ABBREVIATED PLAT AGENDA

July 2, 2025

STAFF REVIEW AND RECOMMENDATIONS
PUBLIC HEARING
JULY 2, 2025

ABBREVIATED PLAT: HUSKY RIDGE

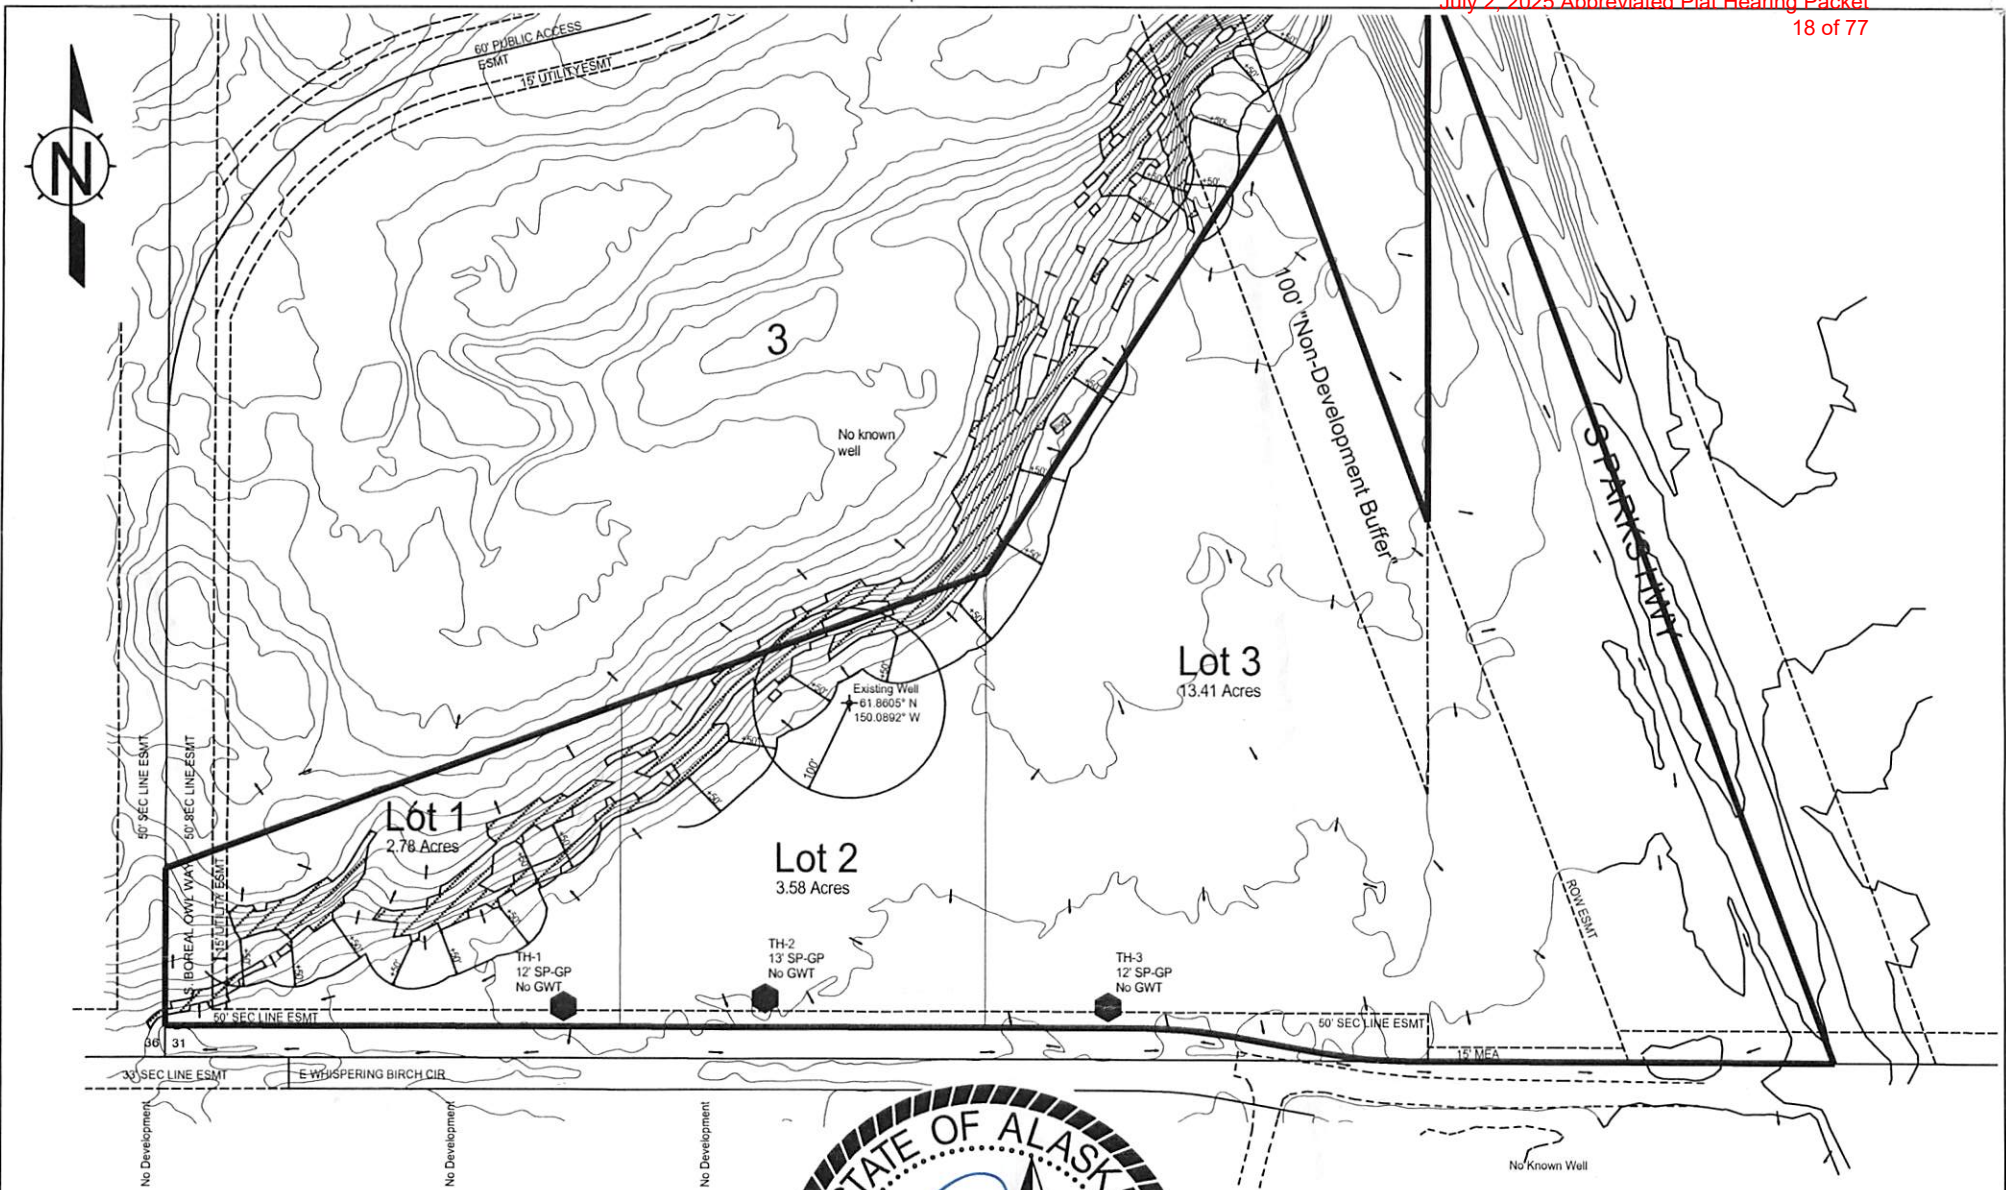
Access and Drainage. The proposed 3 lots will be accessed from their south sides via the E. Whispering Birch Drive ROW, with no direct access to the Parks Highway. It is not clear if road construction will be required. One MSB mapping tool indicates the road is maintained +1,650' or approximately to the west end of this property, and no mention was made in the pre-application comments. General existing drainage patterns are shown on the attached map.

EXHIBIT D

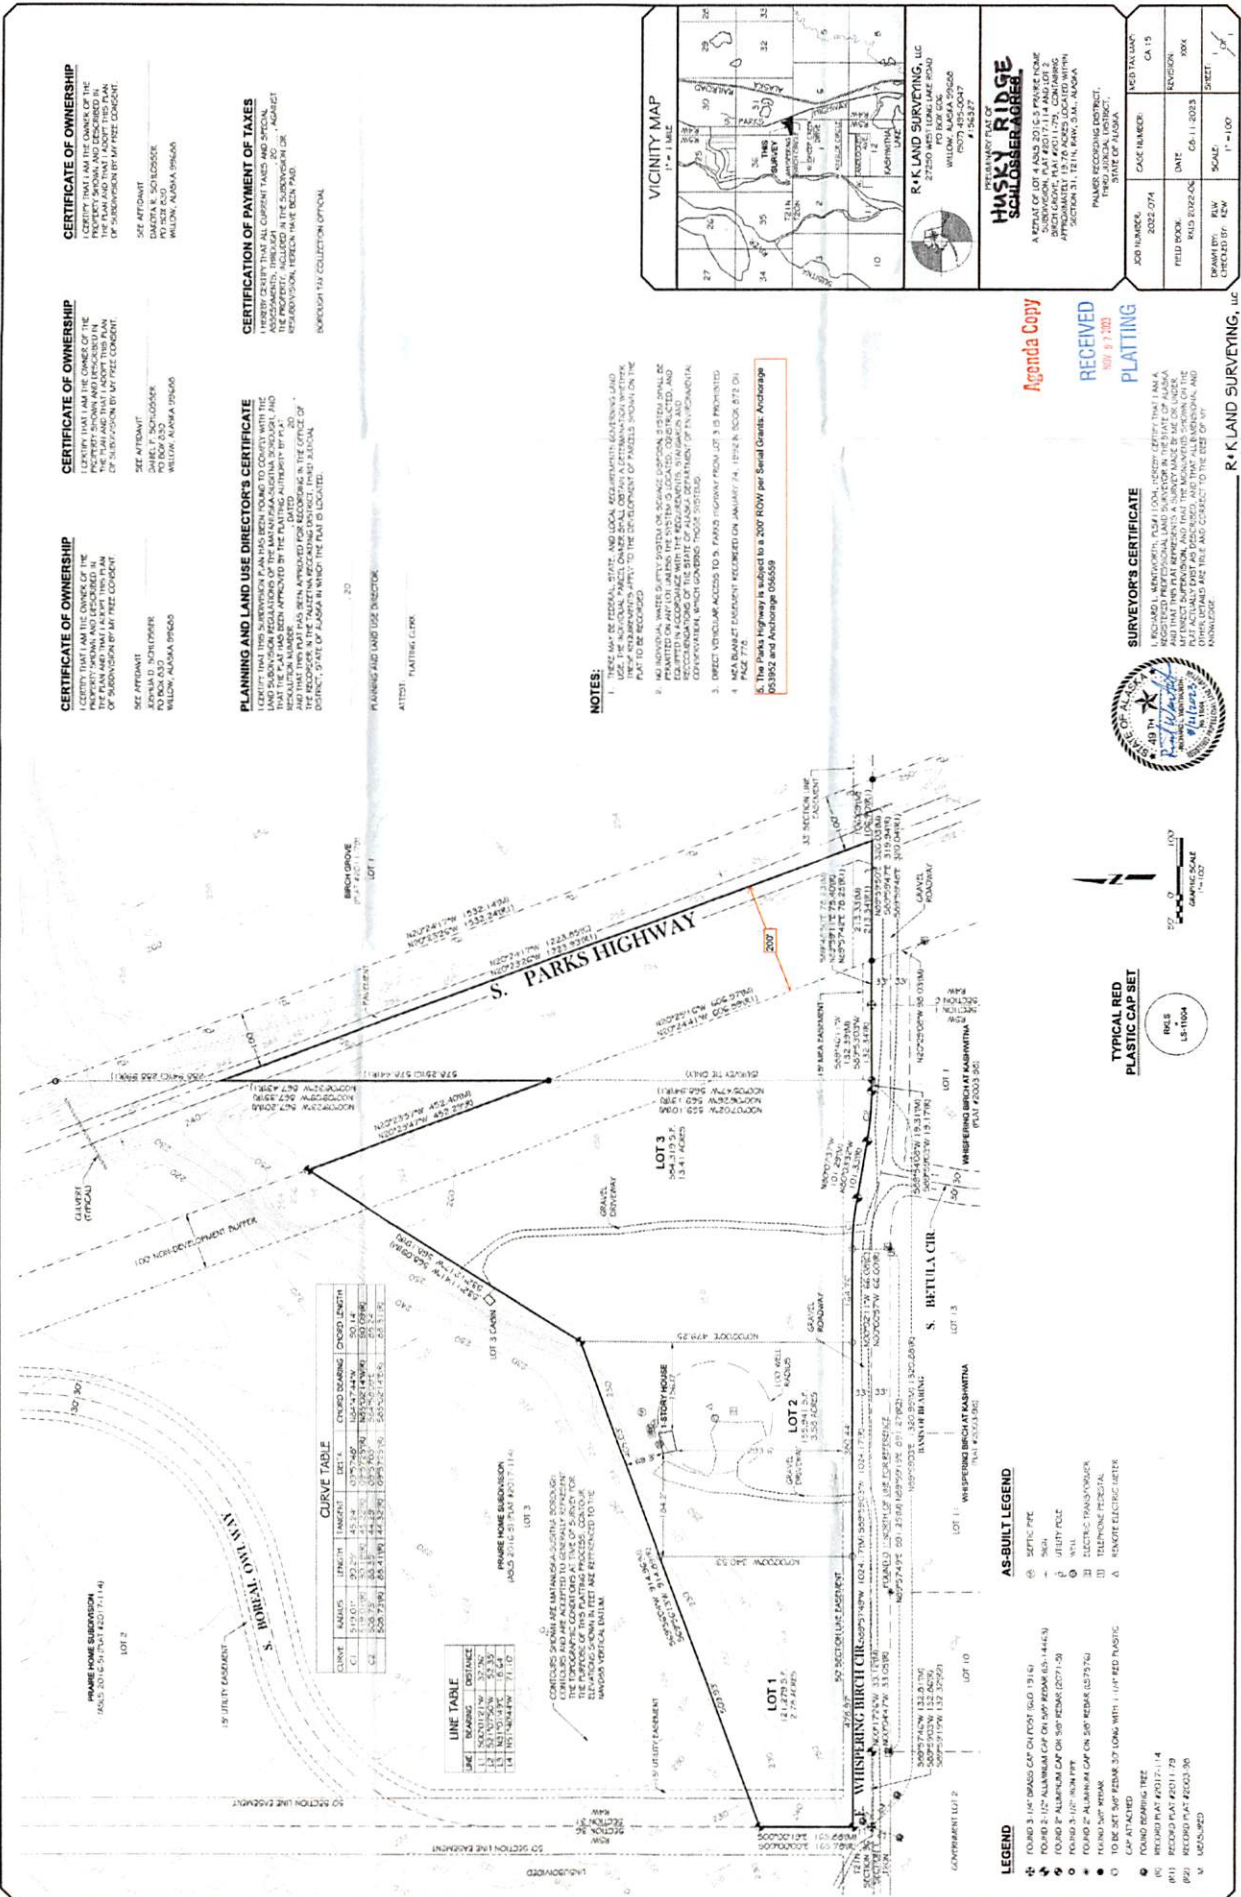
- **Husky Ridge; Plat #2017-114, Plat #2011-79, Plat #2019-24 (Parks Highway MP 78.5) (revised)**
 - Required plat note: "No direct access to Parks Highway for Lot 3."

- Dimension and show 200' Parks Highway right of way granted to the State of Alaska through Lot 3 on plat as shown in attached diagram.
- Add plat note: "The Parks Highway is subject to a 200' ROW grant per Serial Grants: Anchorage 053952 and Anchorage 056559."
- Request Parks Highway right of way dedication.

6. Clearly show and label the Parks Highway right of way through Lot 3.
7. Add a plat note: "The Parks Highway is subject to a 200' ROW grant per Serial Grants: Anchorage 053952 and Anchorage 056559."
